Access Compliance Report

Public Rights-of-Way

(Curb Ramps)

Intersection ID: 10384	Main Street: E_34TH_ST	Cross Street: N_MYERS_ST	Location: N
ADA ID: 064F9E4ACEA8	Ramp Type: Perp	Initial Pass/Fail: Fail	Overall Compliance: No
Severity Score: 21.25			
Codes/Mitigation Info/Possible Solution		Field Measurements/Component Compliance

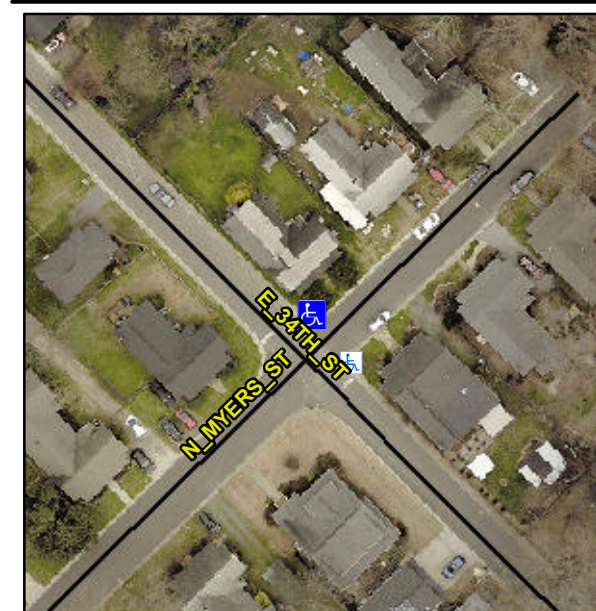
Not Found, R304.5.1, R304.2.2

Compliance	Description	Data	Compliance	Description	Data
N/A	Ramp Length (in)	26.0	No	Ramp Slope (%)	9.4
No	Ramp Width (in)	47.5	Yes	Ramp XSlope (%)	1.4
N/A	Flare Type LT	N/A	N/A	Flare Type RT	N/A
N/A	Flare Slope LT (%)	N/A	N/A	Flare Slope RT (%)	N/A
N/A	Flare Traversable LT?	N/A	N/A	Flare Traversable RT?	N/A
N/A	Landing Length (in)	N/A	N/A	DWS Provided?	N/A
N/A	Landing Width (in)	N/A	N/A	DWS Contrast?	N/A
N/A	Landing Slope (%)	N/A	N/A	DWS Length (in)	N/A
N/A	Landing X Slope (%)	N/A	N/A	DWS Full Width?	N/A
N/A	Landing Curb? (Y/N)	N/A	N/A	DWS Offset (in)	N/A
N/A	Shared Landing?	N/A			
N/A	Gutter Ponding?	N/A	N/A	Gutter Slope (%)	N/A
N/A	Gutter Lip Ht (in)	N/A	N/A	Gutter X Slope (%)	N/A
N/A	Painted X Walk1?	No	N/A	Painted X Walk2?	N/A
	X Walk 1 Direction	To SE		X Walk 2 Direction	N/A
N/A	X Walk 1 Width (in)	N/A	N/A	X Walk 2 Width (in)	N/A
	X Walk 1 Slope (%)	0.1		X Walk 2 Slope (%)	N/A
	X Walk 1 X Slope (%)	5.6		X Walk 2 X Slope (%)	N/A

Remove & Replace Entire Ramp.
